UNITED STATES PATENT AND TRADEMARK OFFICE

APPLICATION NO.	FILING DATE	FIRST NAMED INVENTOR	ATTORNEY DOCKET NO.	CONFIRMATION NO.
10/664,695	09/22/2003	Ramani Mani	125643-1	5199
6147 7590 06/07/2007 GENERAL ELECTRIC COMPANY GLOBAL RESEARCH PATENT DOCKET RM. BLDG. K1-4A59 NISKAYUNA, NY 12309			EXAMINER RODRIGUEZ, WILLIAM H	
			ART UNIT 3746	PAPER NUMBER
			MAIL DATE 06/07/2007	DELIVERY MODE PAPER

Office Action Summary

DETAILED ACTION

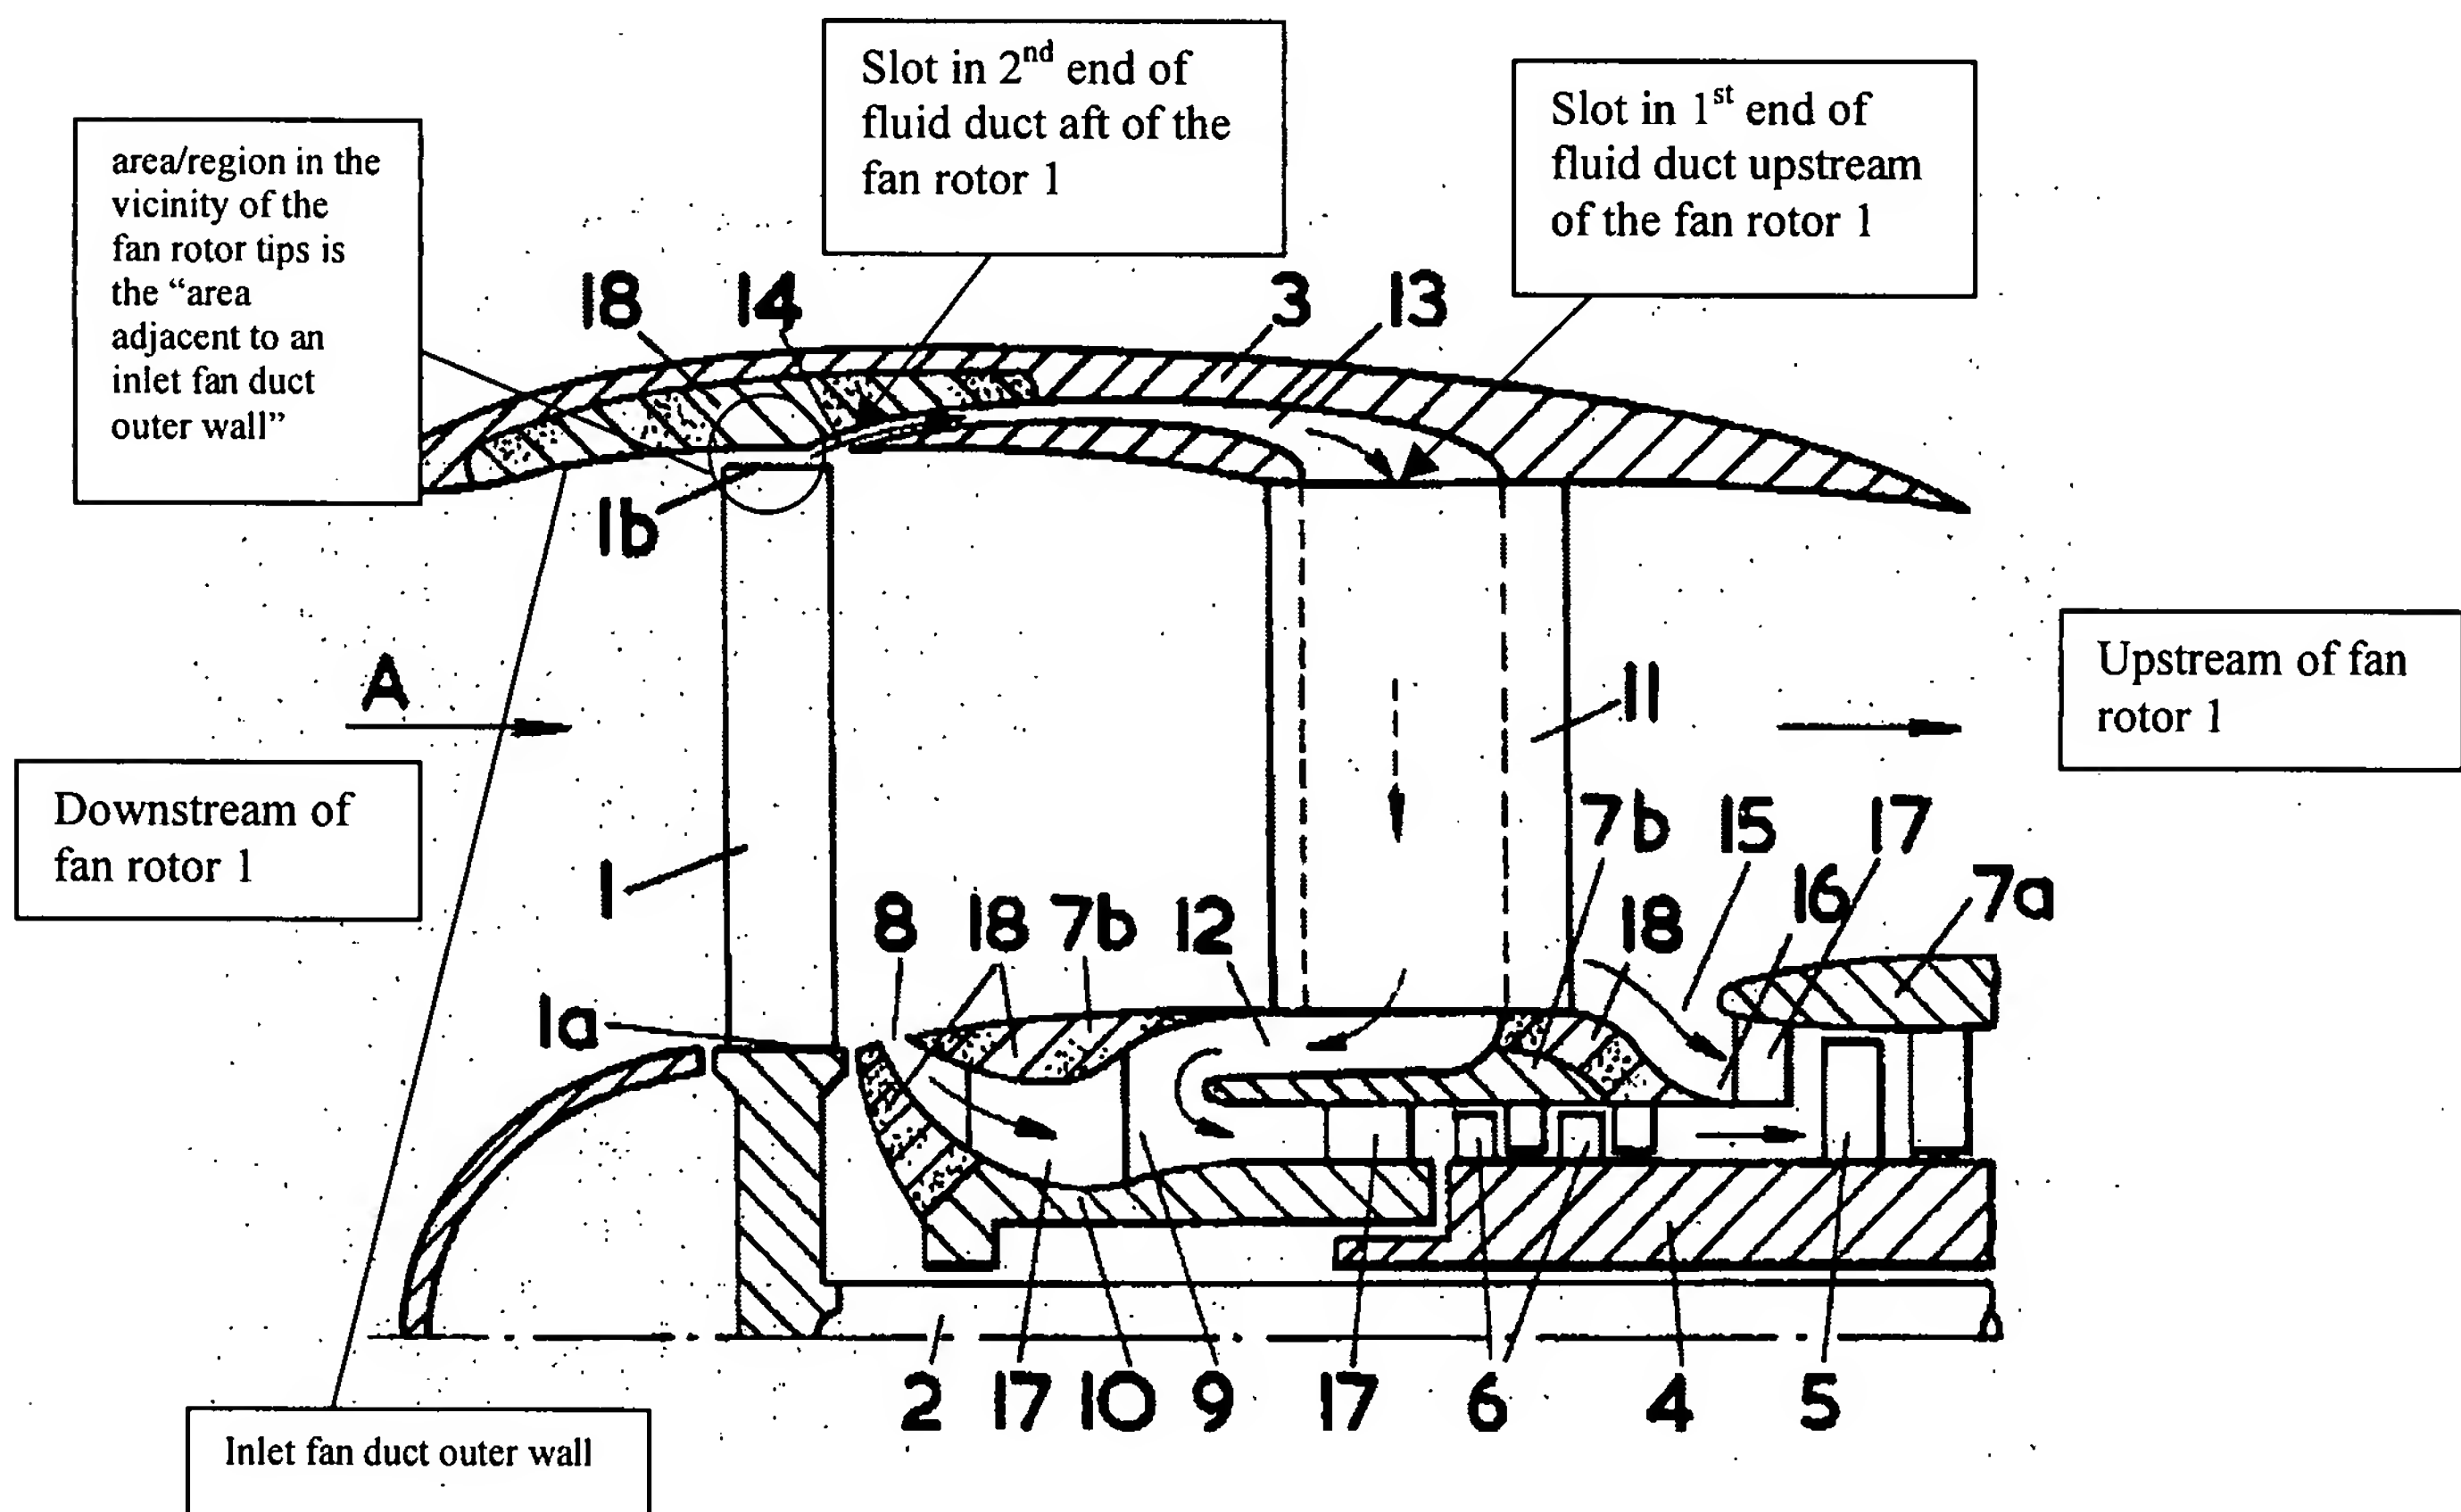
On page 9 of the response applicant argues "Howell does not disclose a first end of the fluid duct that is located upstream of the fan rotor". Examiner disagrees because as clearly shown in figure 1 of Howell the slot in the first end of the fluid duct is located upstream of the fan rotor 1.

On page 9 of the response applicant argues “Howell is not intended to alter the flow speed adjacent to the inlet fan duct, but rather to bleed excess pressure from the immediate vicinity of the fan rotor tips”. Notice that the area/region in the vicinity of the fan rotor tips is the “area adjacent to an inlet fan duct outer wall”. Also, notice that as the flow A enters the 2nd end of the fluid duct the speed/velocity is accelerated because the 2nd has a very small cross sectional area in comparison to the large cross-sectional area of the inlet fan duct of the engine. Therefore, Howell clearly teaches that the air velocity adjacent to an inlet fan duct outer wall is increased.

Howell teaches an apparatus comprising: a nacelle 3, an acoustic liner 18, a fluid duct 13 having a first end with a slot being disposed upstream of a fan rotor 1 and a second end with a slot disposed aft of said fan rotor 1, said fluid duct said first slot and said second slot being circumferential as indicated by the presence of the centerline on the bottom of figure 1. Notice that the cross sectional area of the second end expands towards the first end, said fluid duct is substantially disposed within the nacelle. Notice that the area/region in the vicinity of the fan rotor tips is the “area adjacent to an inlet fan duct outer wall”. Also, notice that as the flow A enters the 2nd end of the fluid duct the speed/velocity is accelerated because the 2nd has a very

small cross sectional area in comparison to the large cross-sectional area of the inlet fan duct of the engine. Therefore, Howell clearly teaches that the air velocity adjacent to an inlet fan duct outer wall is increased. See particularly figure 1 above.

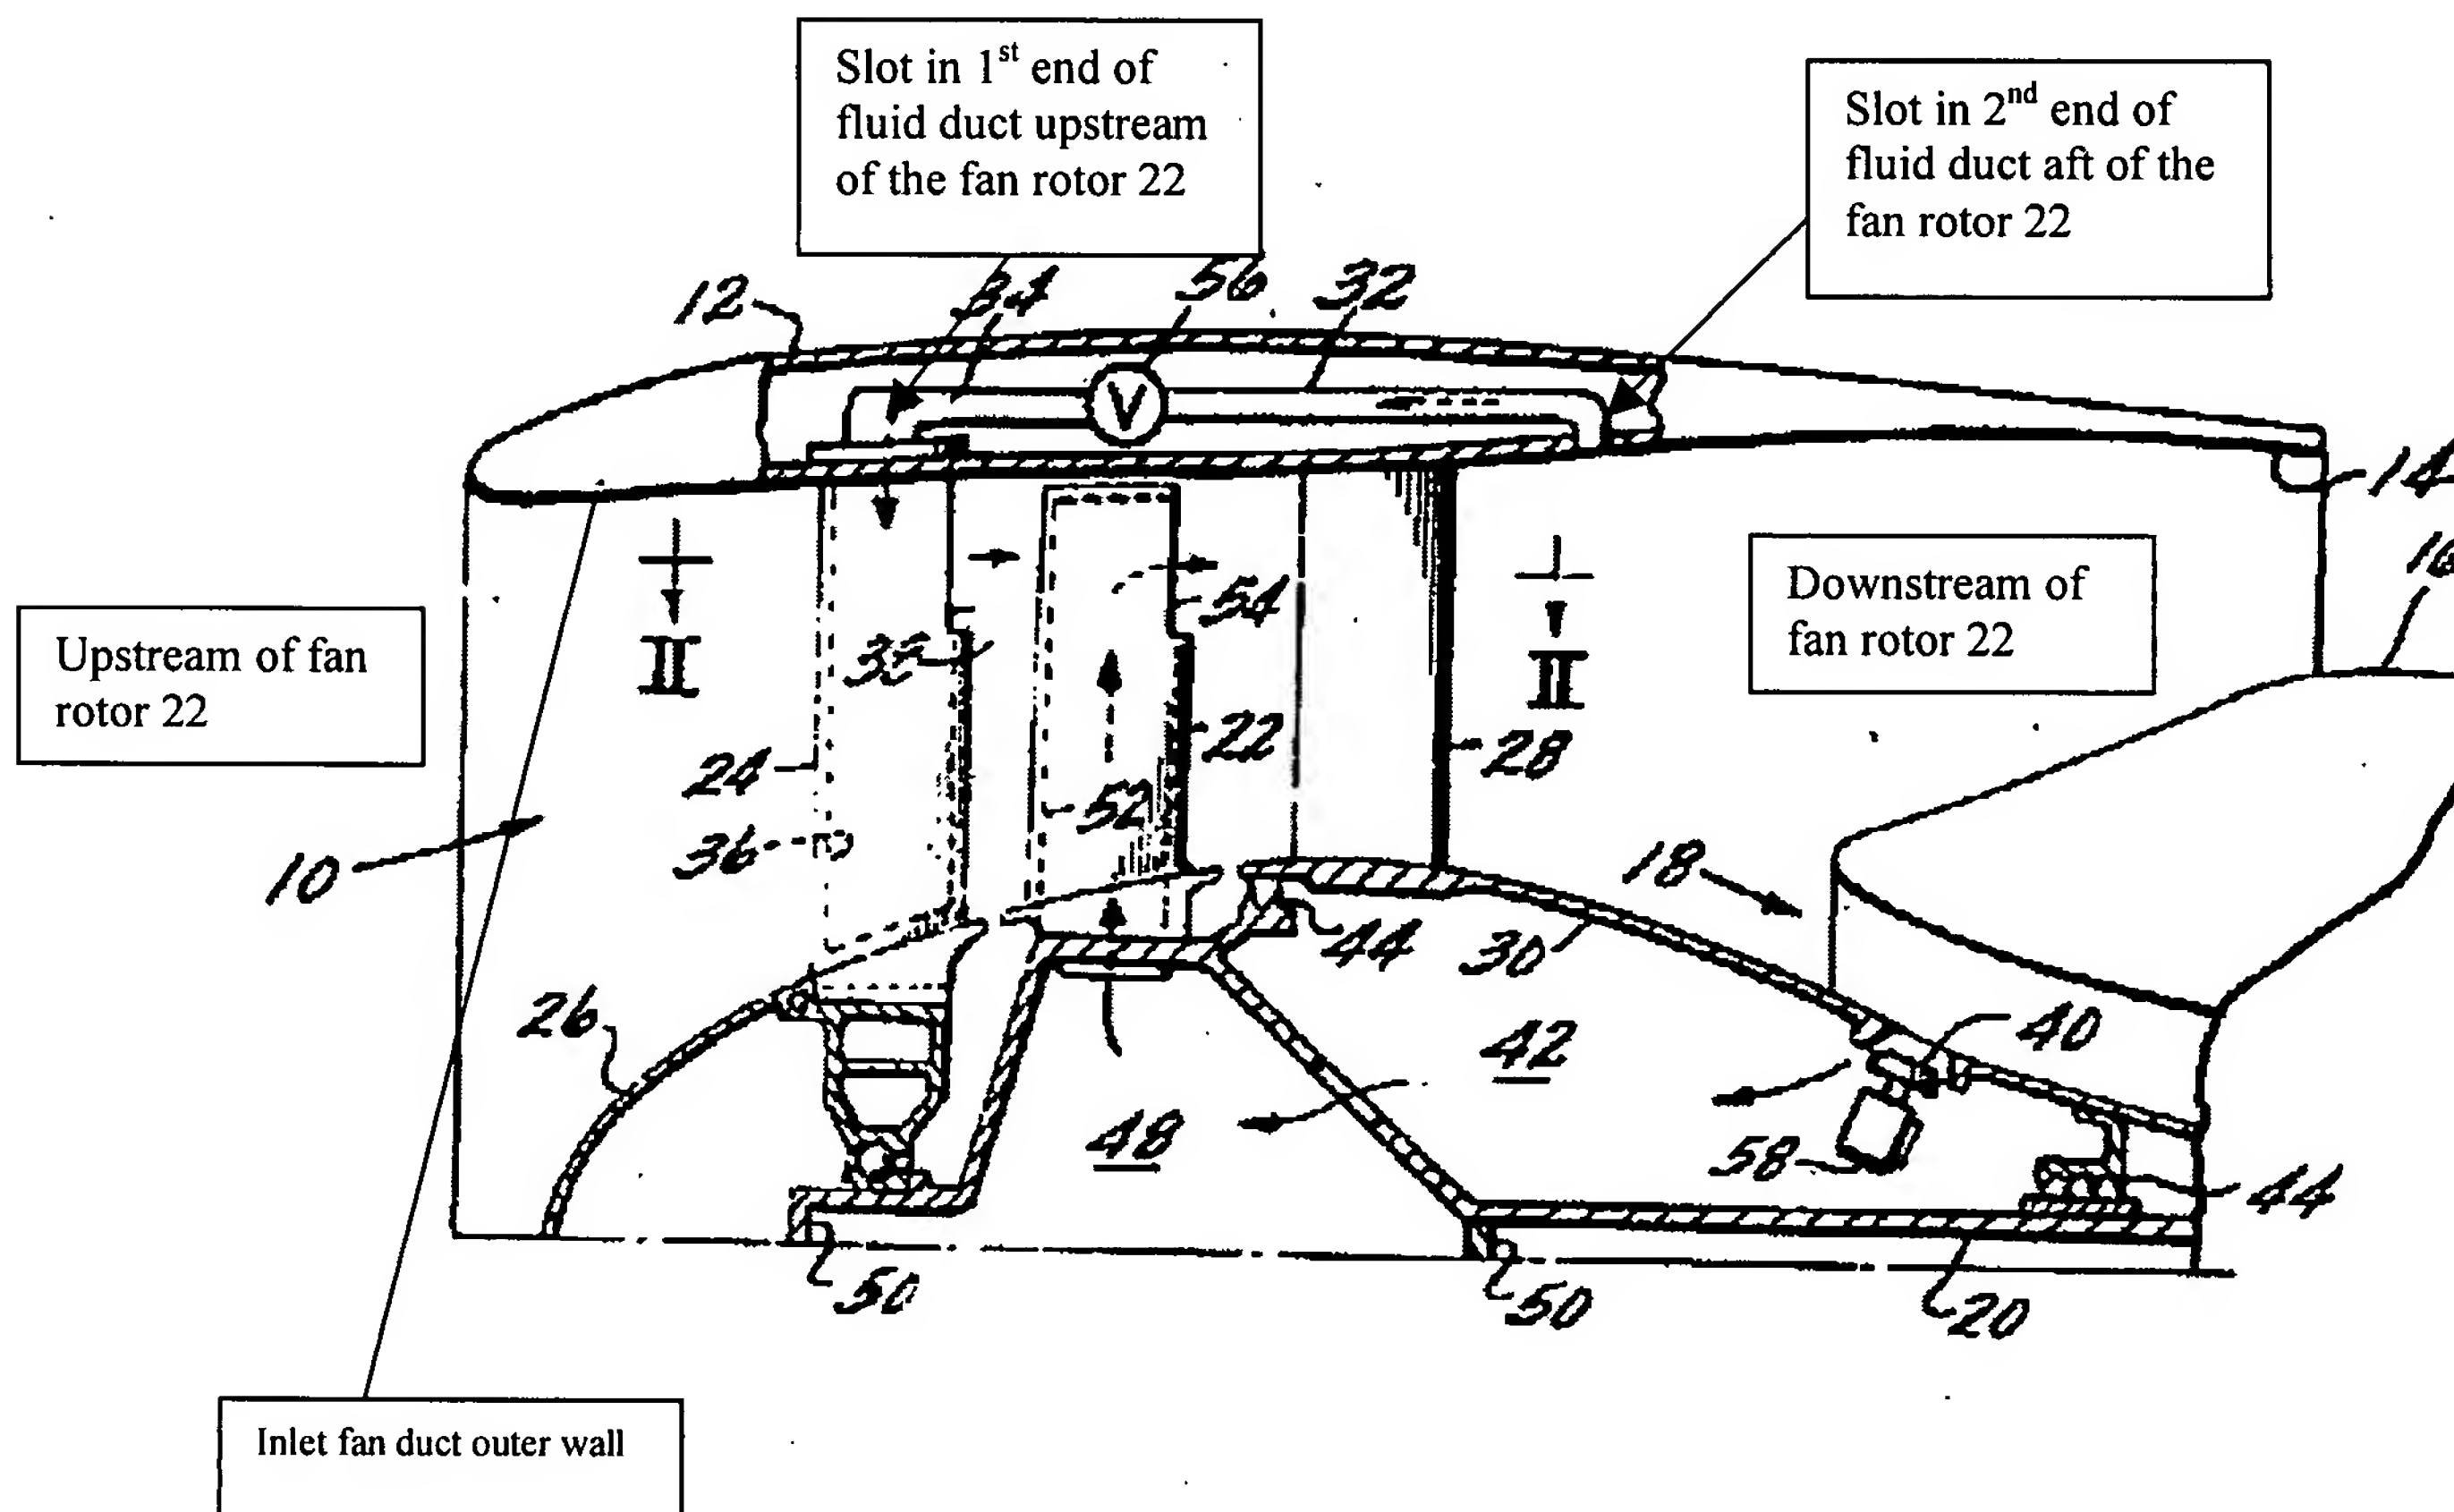
5. Claims 20 and 29 are rejected under 35 U.S.C. 103(a) as being unpatentable over Howell (US 3,735,593).

6. Regarding the claimed limitations "said fluid duct is of sufficient dimension", to the extent that the claimed invention produces the claimed desired results, the applied prior art structure being the same, does the same. In addition, it has been held that "[W]here the general conditions of a claim are disclosed in the prior art, it is not inventive to discover the optimum or workable ranges by routine experimentation." In re Aller, 220 F.2d 454, 456, 105 USPQ 233, 235 (CCPA 1955), MPEP 2144.05 II. The sizing of the duct is considered a desired result that would be an obvious design optimization of said duct.
